Results of Independent Testing of SFEI's Multibox Model for PCB Fate and Transport

Prepared For:
Clean Estuary Partnership

Prepared by:
 Tetra Tech, Inc.
Lafayette, CA

September 2, 2005

Figure 33. Cumulative PCB mass in and out of Bay based on model V.2b predictions.

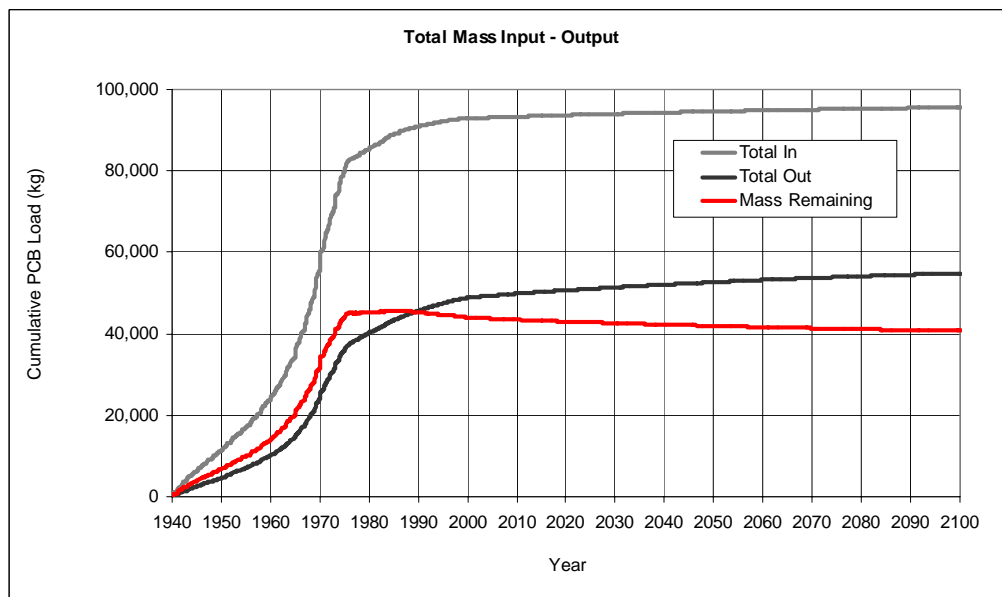
- Since about 1990, according to the model, the total amount of PCBs remaining in the Bay is decreasing. To reduce (or remove) the dependence of model predictions on the highly uncertain loading reconstruction, an alternative approach to initializing the model could be to use the coring data to be collected in 2005 and estimates of present and future of PCB loads, rather than trying to recreate such a long hindcast period. Figure 34a illustrates a factor of 10 load change for PCBs to the Bay over the hindcast and forecast periods. This range is the same chosen by Breivik in Figure 8 of the draft report. The hindcast and forecast total PCB concentrations in the water column for the Lower South Bay and Suisun Bay are superimposed on the PCB load in Figure 34b. It is clear from this figure that the predicted concentrations respond very strongly to loading changes. This indicates that, should evidence support significant decreases in loading, predicted concentrations could be much more in-line with observations.

In contrast, according to the MBM over 40 percent of the PCB-118 discharged is predicted to remain in the Bay today (see Figure 33). The more heavily chlorinated PCBs would likely be present at even higher percentages than PCB-118. Suggestions to address these issues are:
